REV	22	BUILDING:	AUX
ISO NO.:	MCFI INI-34	DUKE PIPING CLASS:	B
SYSTEM SYMBOL: NI SAFETY INJECTION SYSTEM			
PIPING SPEC: NI 41-PS-1501-2			
DRAWING NO.: MC-1414-09-43-01-02-03			
PROJECT MC GUIDE			
4 LAST FLANGED JOINT NO. USED			
REV	NO.	DATE	DESCRIPTION
1	0		REL. FOR CONST.
2	1	10-4-76	ADDED CONT. OF ISO.
3	2	10-4-76	ADD MAT. S AND *NOTE AND DELETE MIN. J AT NIF 1240
4	3	10-4-76	ADDED MAT. 5 AND WELD NIF 1547 (PER V.N. 6635)
5	4	10-4-76	ADDED FLANGED JOINT NOS. 1-4 (REVISED TO ADD NIF 1885)
6	5	10-4-76	REVISED TO ADD NIF 112, 113, 114, 127, 128
7	6	10-4-76	REVISED TO ADD APPROXIMATE MAT. (REVISED TO ADD NIF 1249)
8	7	10-4-76	REVISED TO ADD APPROXIMATE MAT. (REVISED TO ADD NIF 1249)
9	8	10-4-76	REVISED TO ADD APPROXIMATE MAT. (REVISED TO ADD NIF 1249)
10	9	10-4-76	REVISED TO ADD APPROXIMATE MAT. (REVISED TO ADD NIF 1249)
11	10	10-4-76	REVISED TO ADD APPROXIMATE MAT. (REVISED TO ADD NIF 1249)
12	11	10-4-76	REVISED TO ADD APPROXIMATE MAT. (REVISED TO ADD NIF 1249)

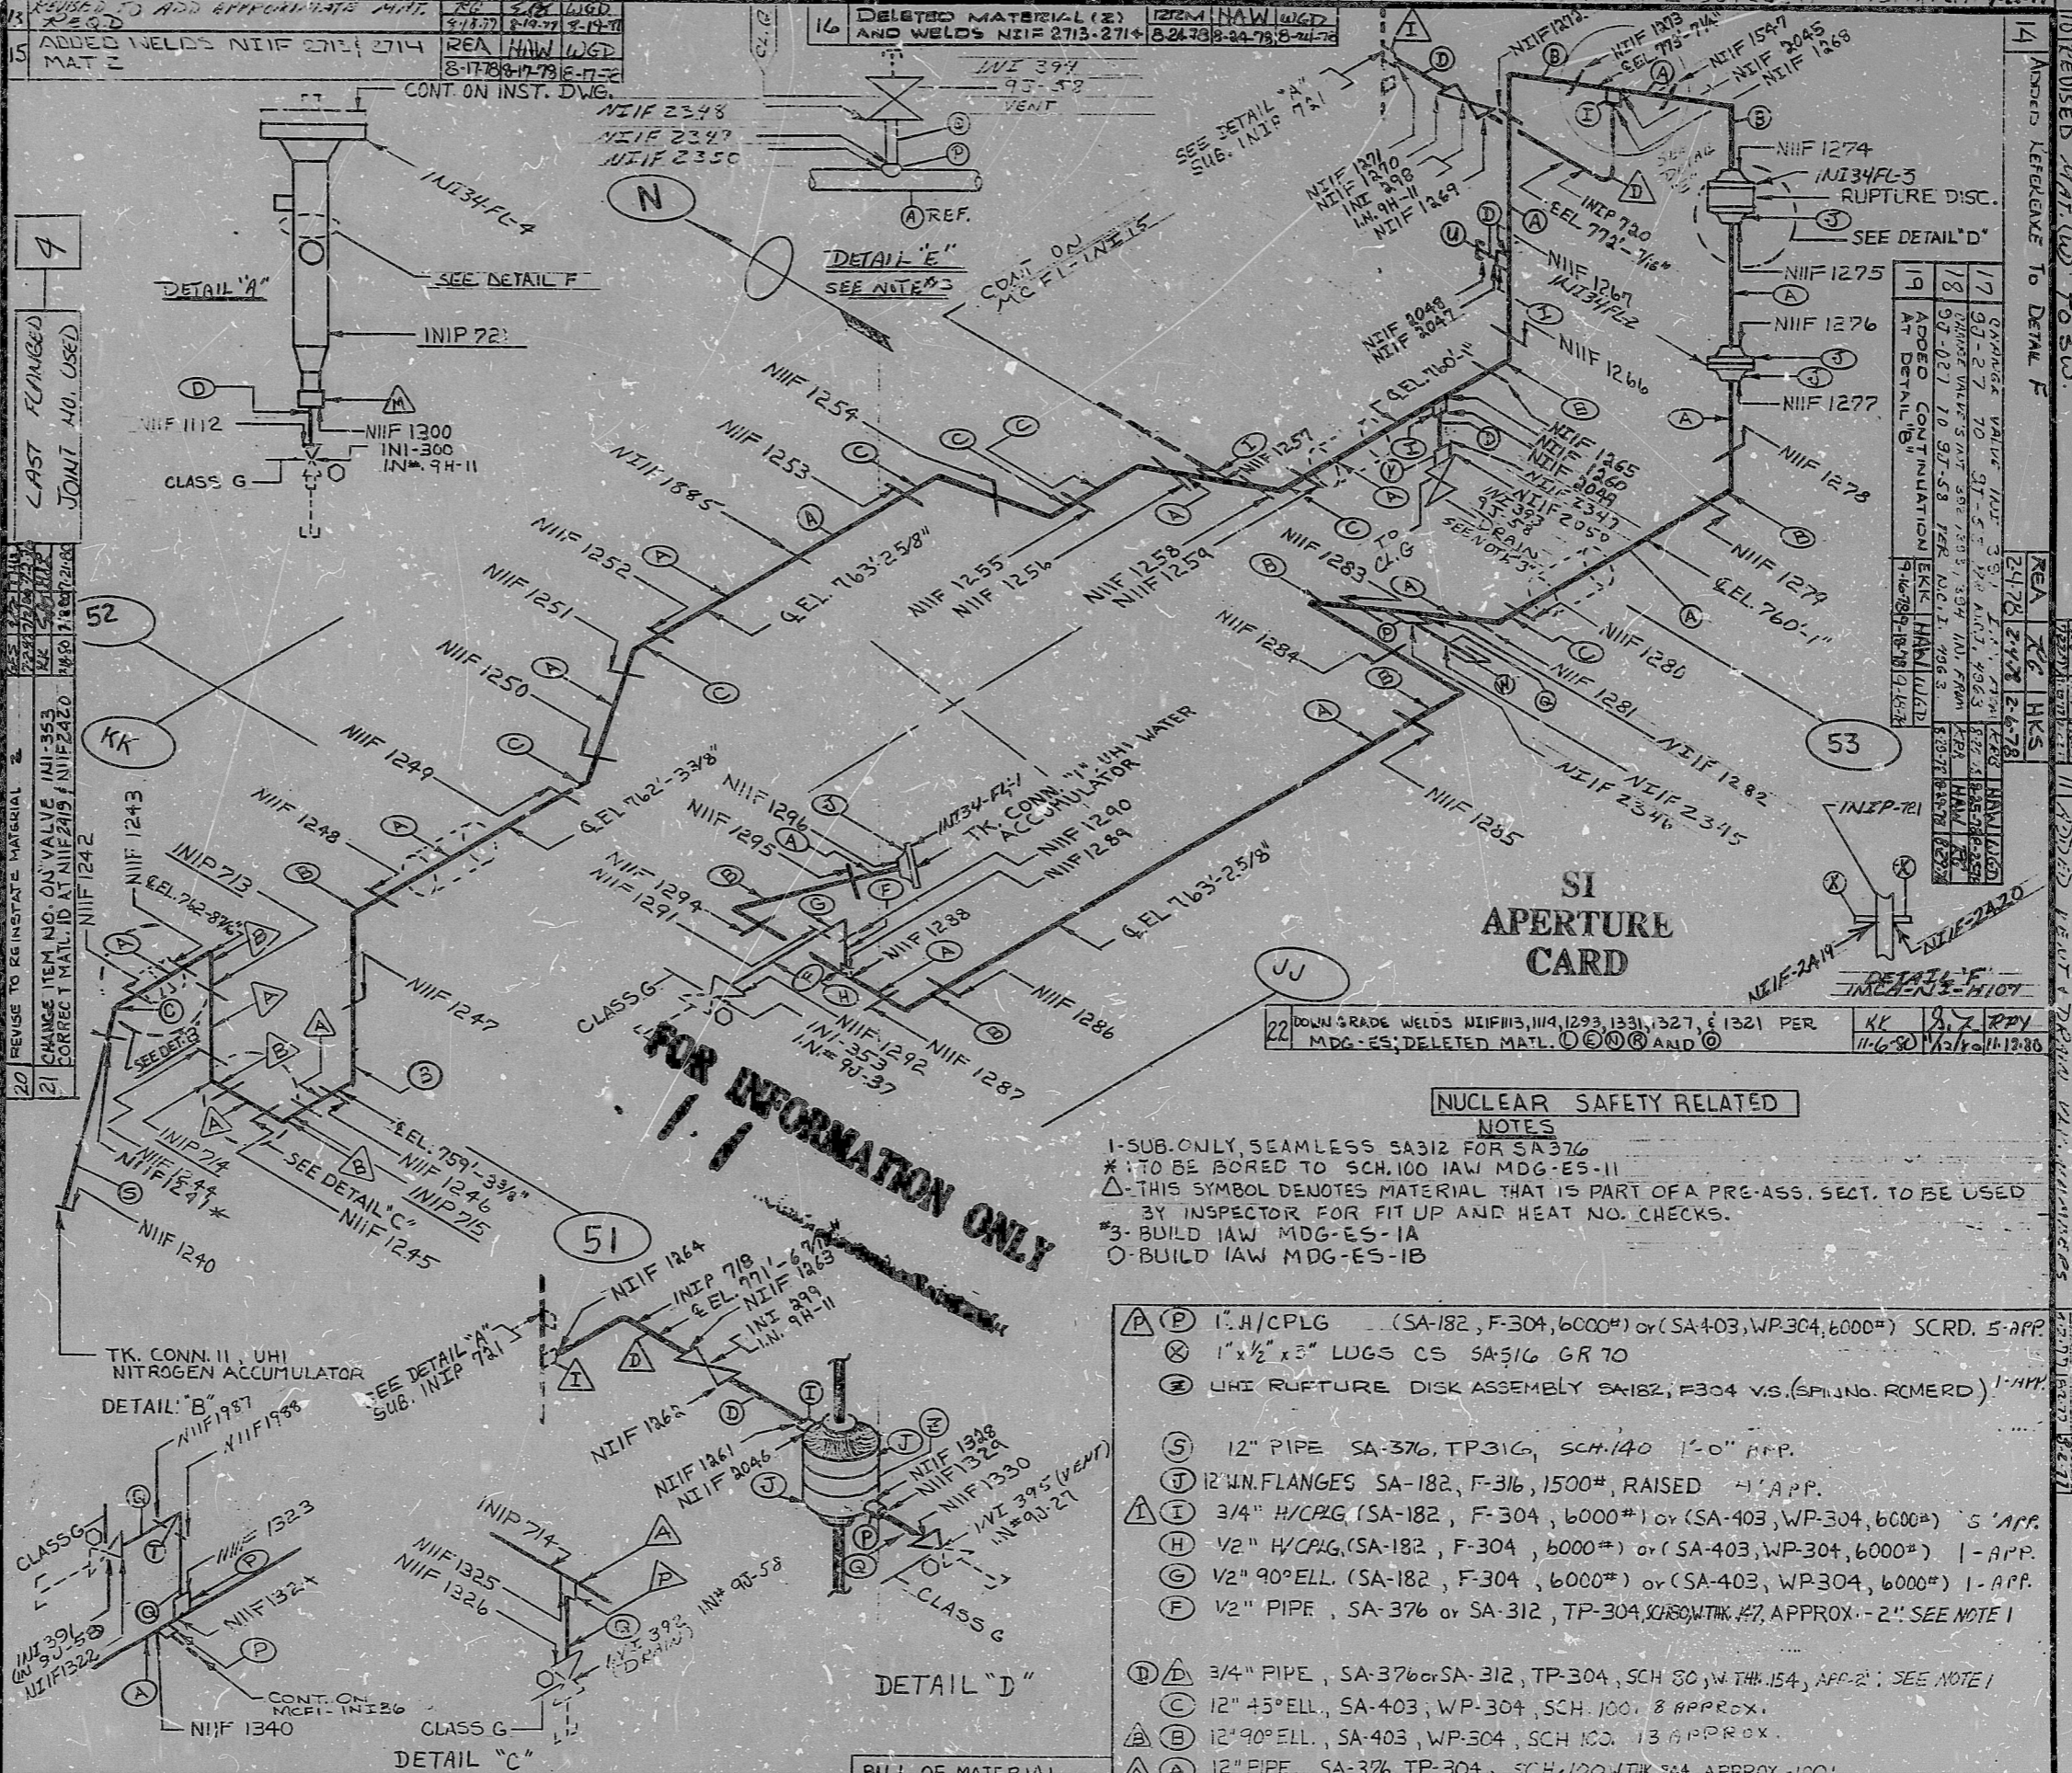
7 MAJOR CONFIGURATION ON 3/4" LINES; ADD MAT.'S T, U, HAW (EDH) (KUS) (6-3-77) 8 CHANGED CONE OF INIP 721 (PER N.C.I. # 3096) (HAW) (EDH) (KUS) (6-30-77) (6-21-77) 9 ADDED PIECES Q+W AT WELDS (NIF 2305) (KUS) (7-21-77) (7-21-77)
